RE – Yass Valley Wind Farm Preferred Project Report response (our ref. 4743)

Thank you for providing the OEH comments regarding this project, addressed to Department of Planning and Infrastructure, dated 29 August 2013.

ISSUES AND APPROACH OVERVIEW

1 CLARIFICATION OF ISSUES / DISCREPANCIES RAISED IN OEH SUBMISSION

TITLE
 Project Infrastructure &
 Vegetation
 Complete site

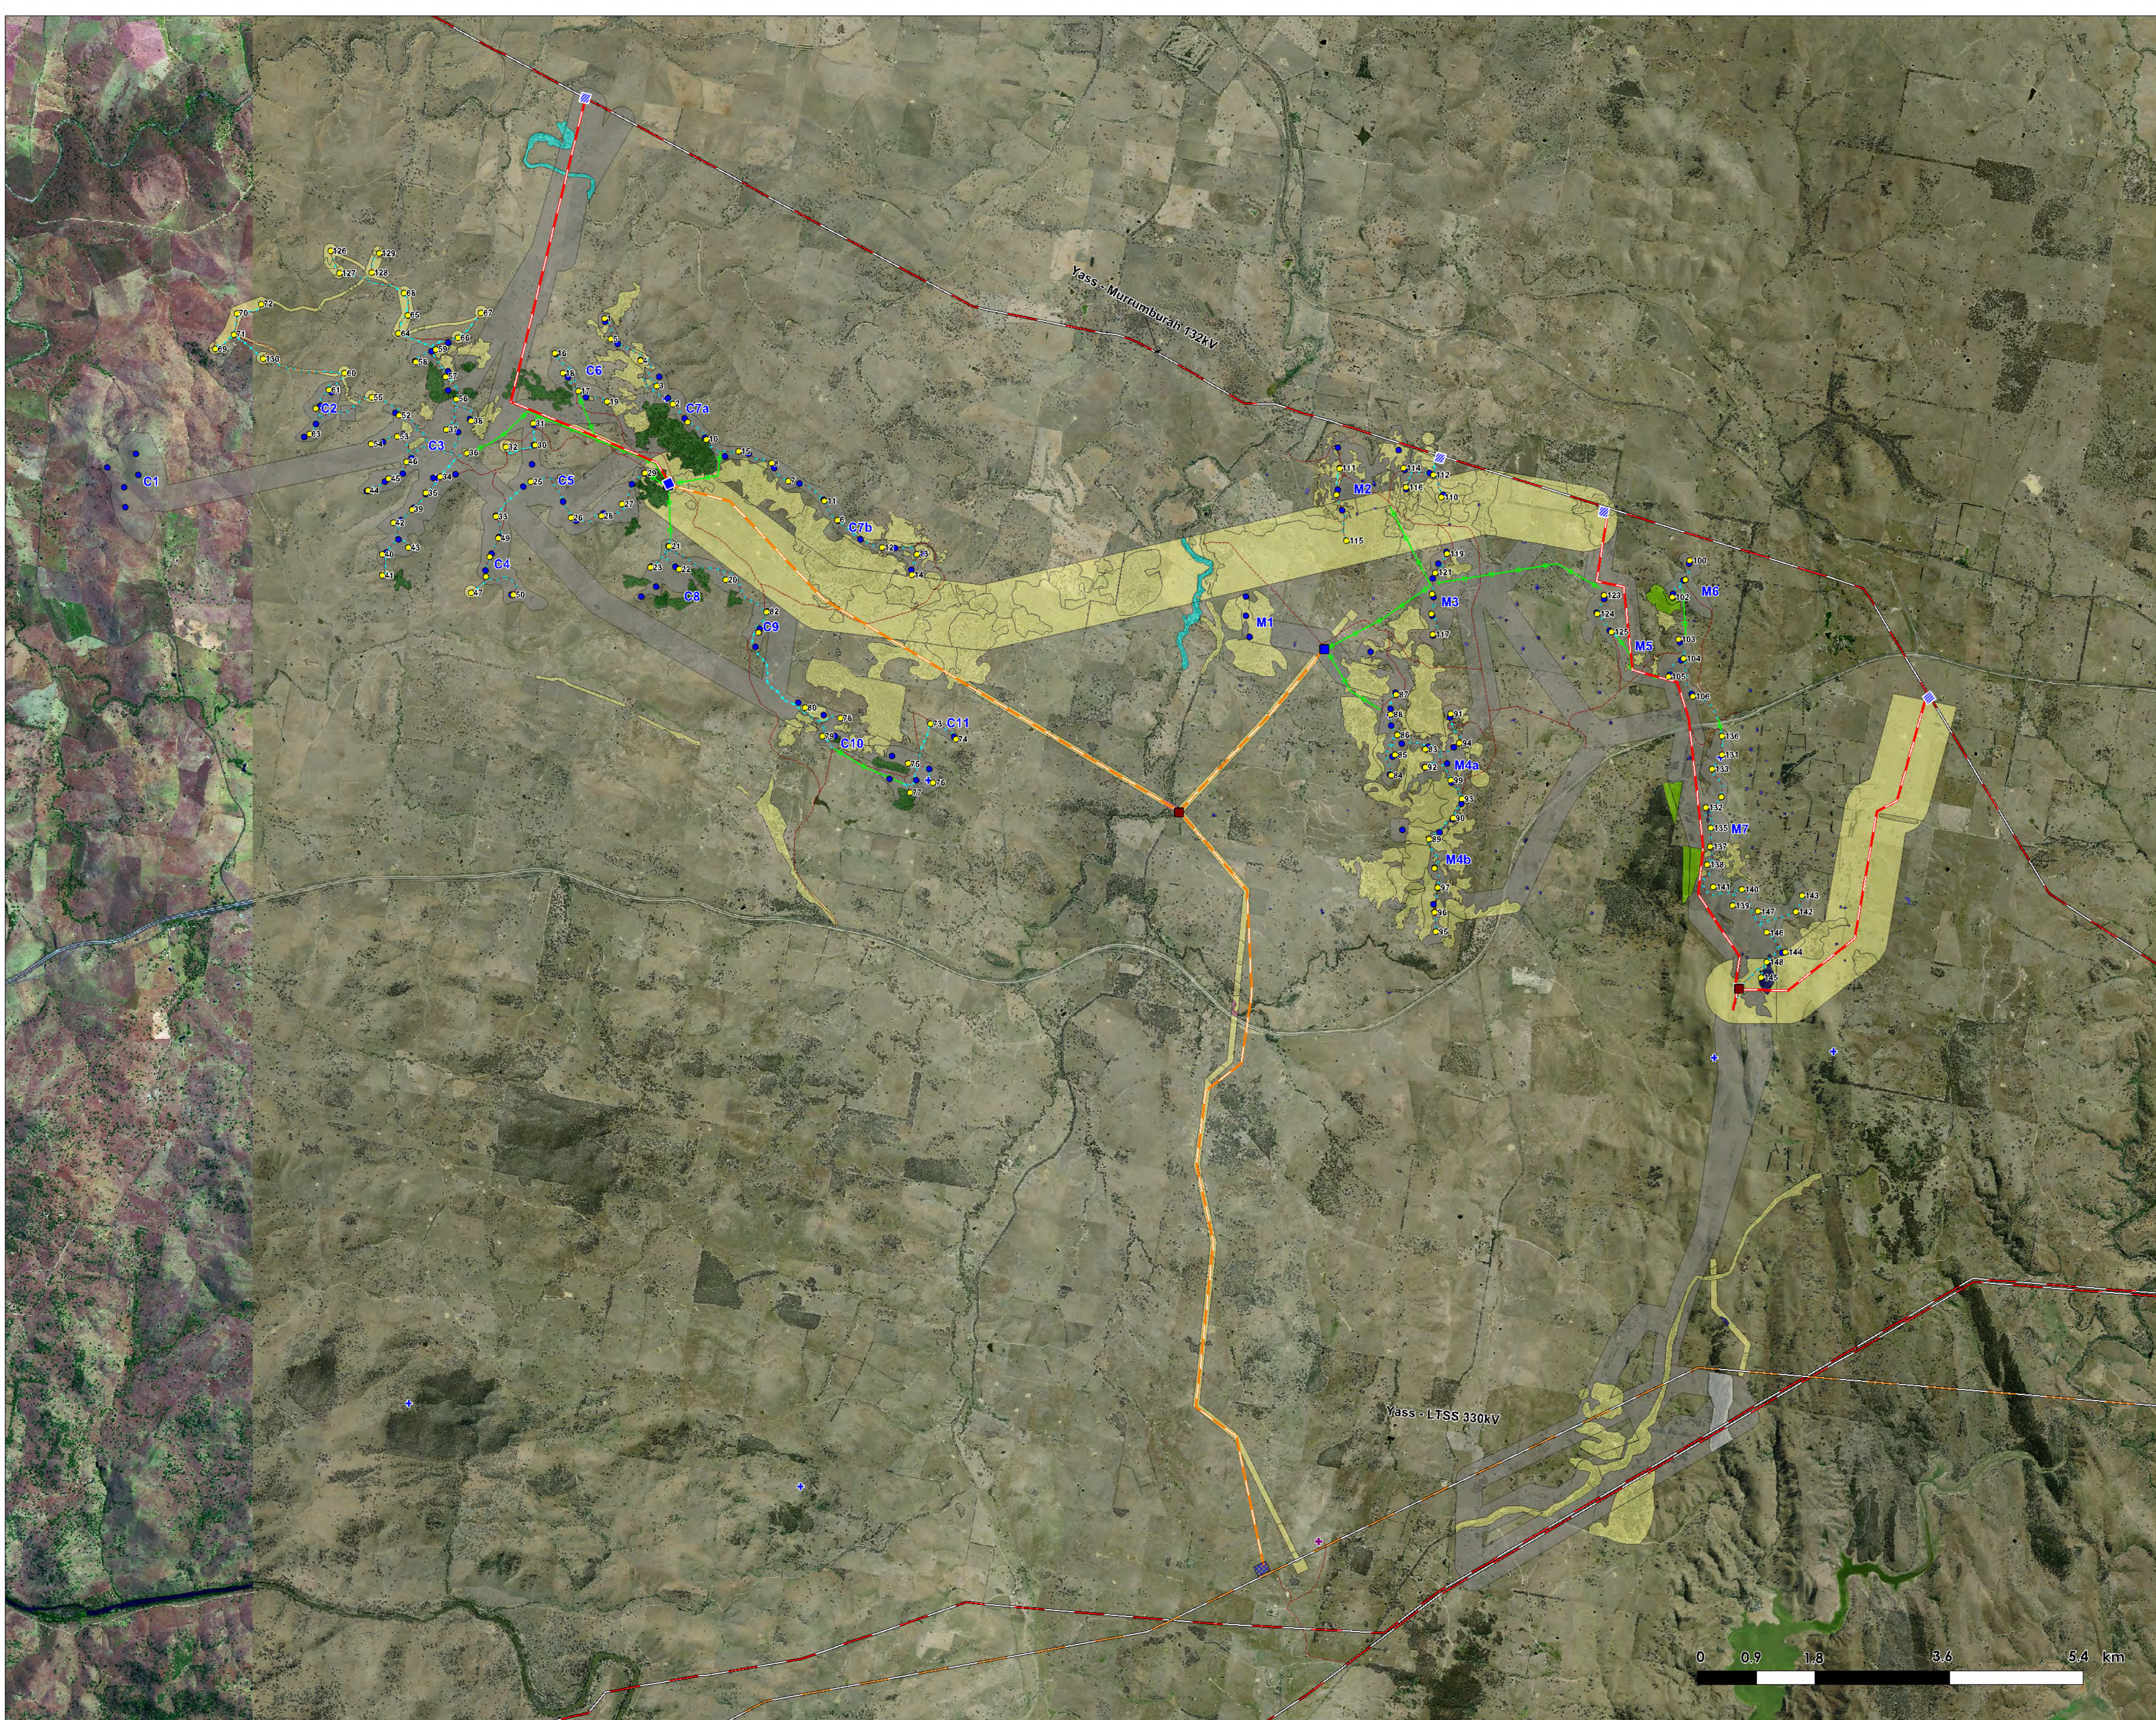
1. Layout comparison EA vs PPR layout, showing changes in turbine layout since the publically exhibited EA.
2. Vegetation types Updated vegetation mapping to show ‘worst case’ clearing estimate of EEC vegetation:
 - Areas of ‘pasture’ and ‘exotic’ vegetation have been moved in to Box Gum Woodland in poor-moderate condition, as a precautionary treatment, in advance of detailed field validation.
 - EEC in ‘moderate to good biometric condition’ has been outlined.

It is noted that the additional areas of vegetation now reassigned as ‘moderate to good’ biometric condition are comprised of the lower condition areas, considered to be highly degraded and therefore not originally mapped as EEC. These are areas of low tree density and large proportion of exotic understorey, as verified with OEH on the site inspection (November 20, 2013). In the absence of ground truthing, we have included these as ‘moderate to good’ biometric condition to demonstrate offsets are achievable for this area.

TITLE
Biodiversity
High constraint areas

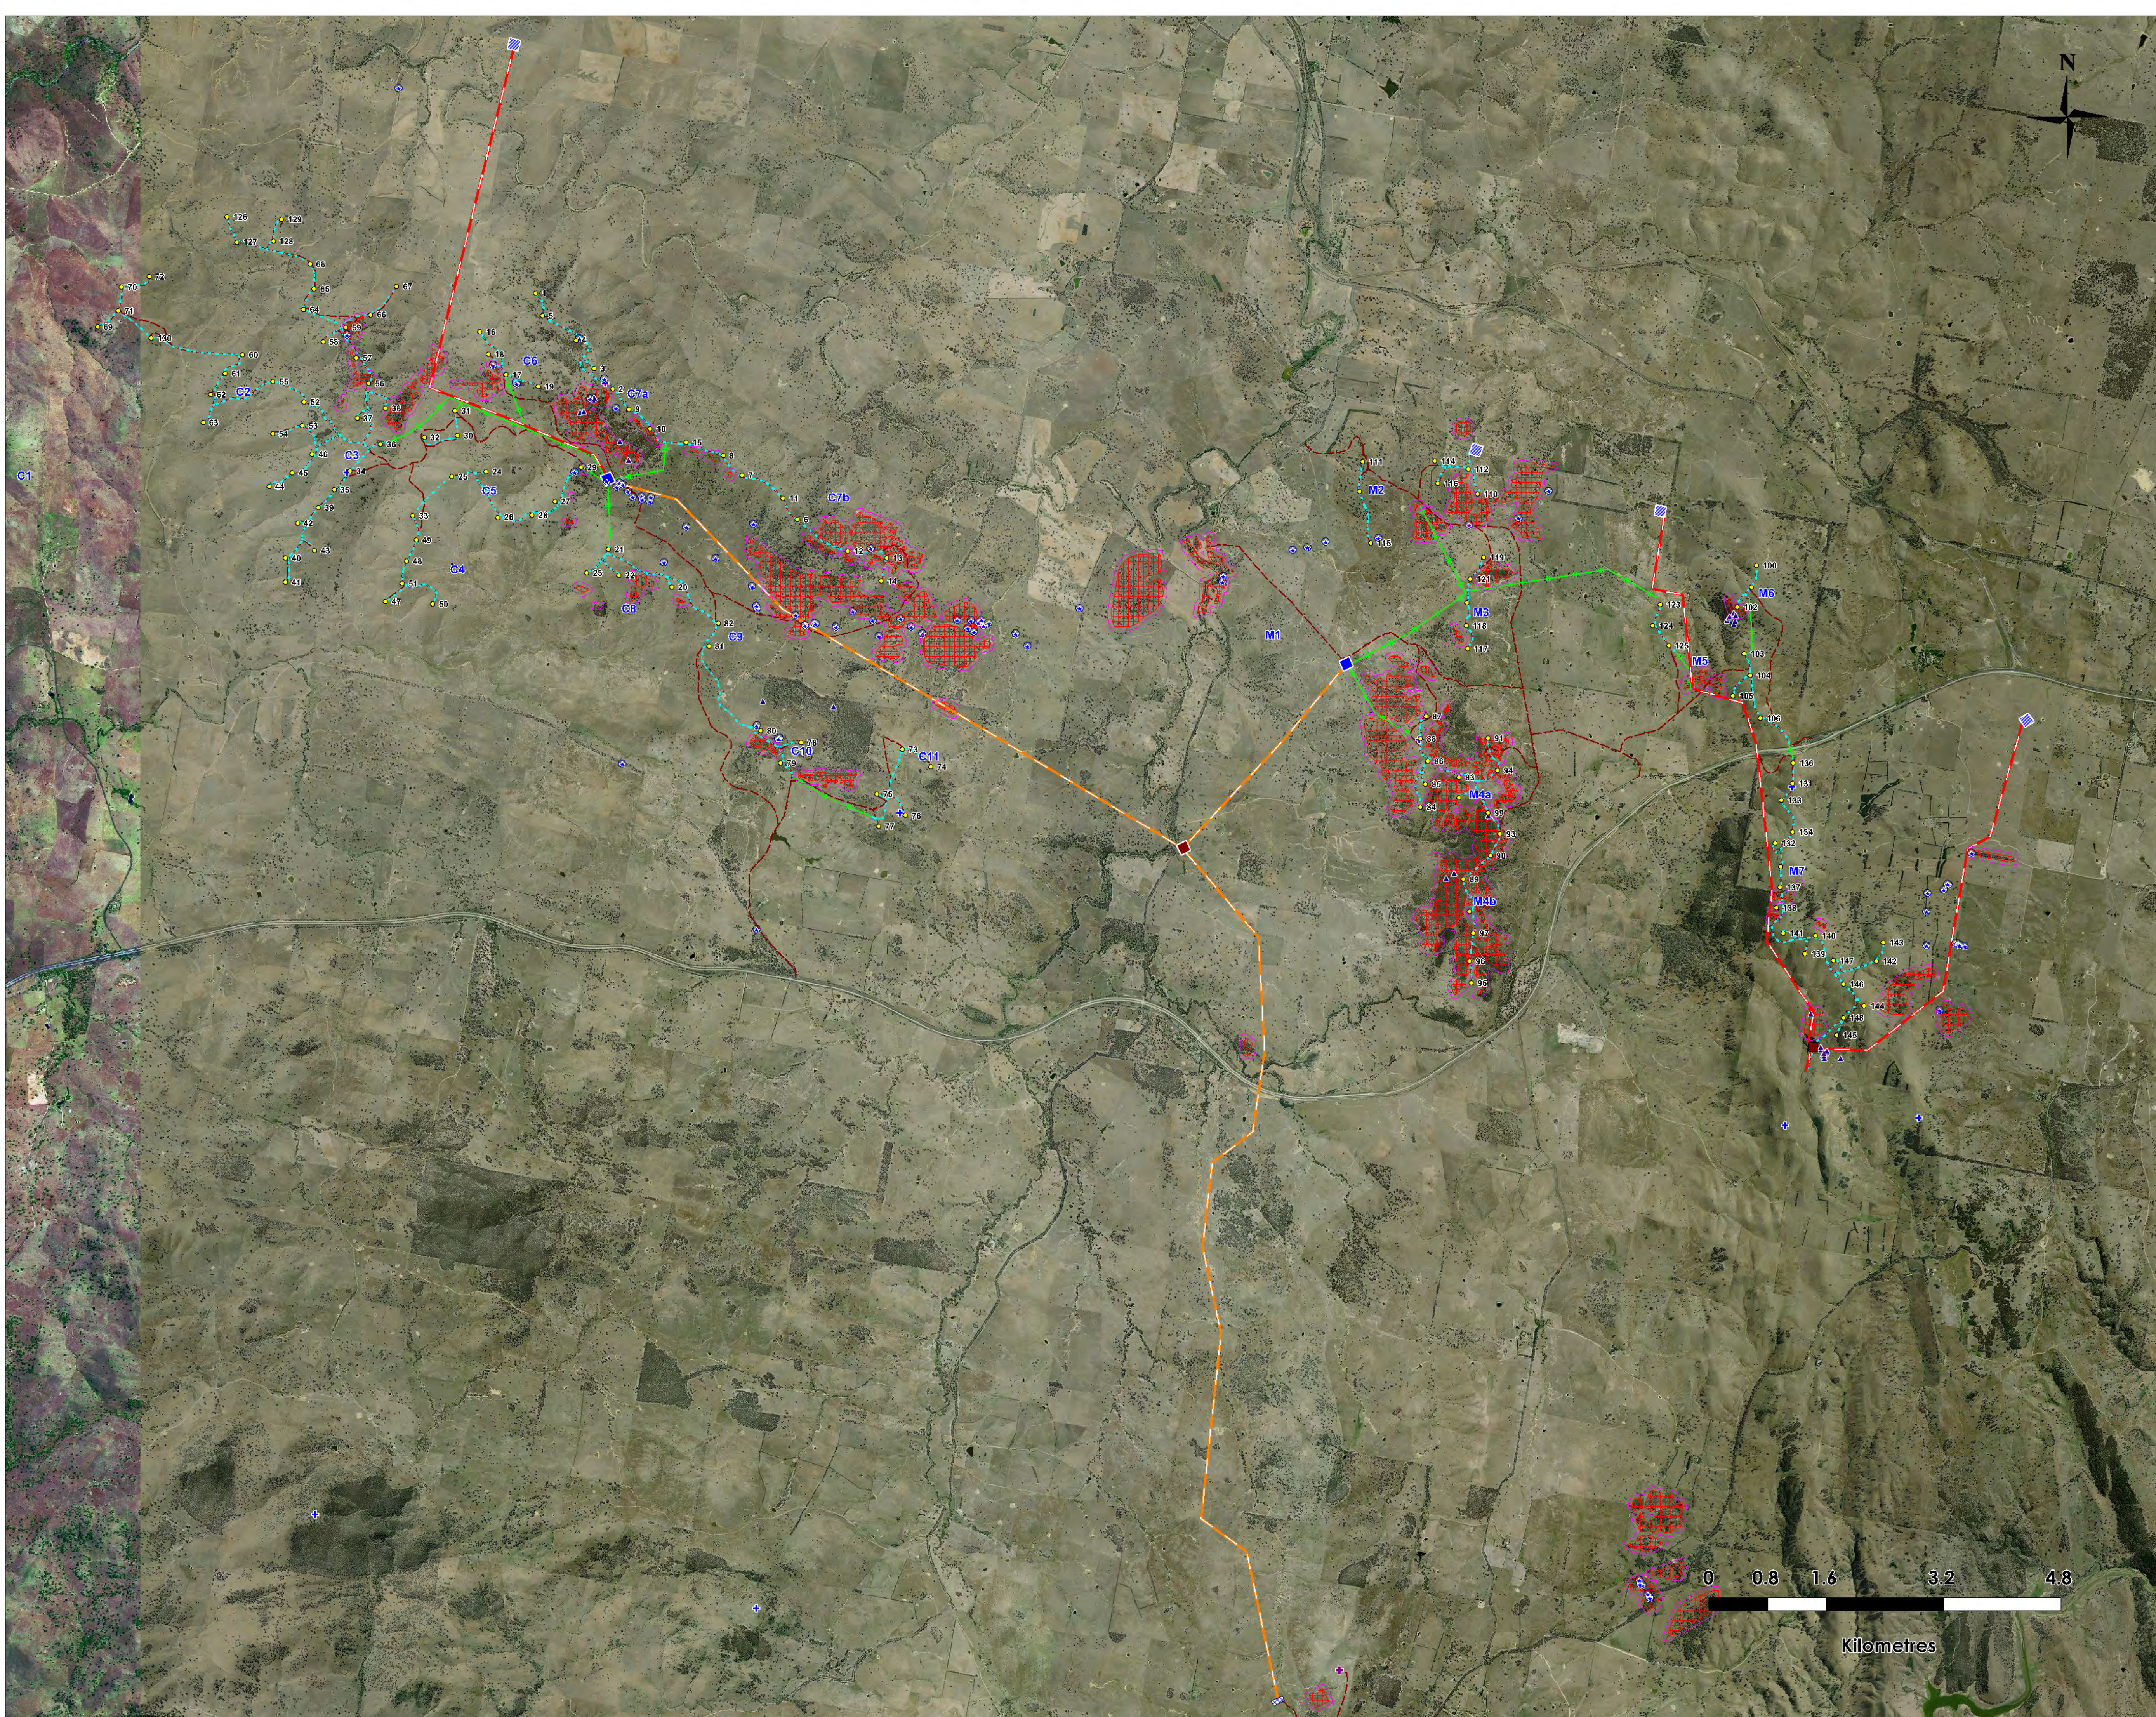
3. High constraint High constraints from the BAs and SER are mapped. This includes:
 - WF site (BAs):
 - EEC in ‘moderate, moderate to good and good’ condition

- Woodland fauna and threatened fauna habitat
 - Marked hollow bearing trees (not exhaustive)
 - TX line (SER):
 - EEC in ‘moderate to good and good’ condition

- Likely movement corridors in woodland and forest
 - Threatened species habitat

- Yass Daisy locations with 5m buffer.

It is noted that the impact of turbines within high constraint areas is not the same as tracks or transmission infrastructure. Some fine scale mapping has been undertaken to allow minimum width tracks in high constraint areas. In these areas, minimising impact on overstorey vegetation can be seen to have been achieved. Where transmission lines occur in high constraint areas, pole footings can be placed either side of the high constraint boundary or in a way that avoids tree clearance.
4. Potential offset sites Potential offset areas include connected mature woodland, EEC and threatened species habitat.
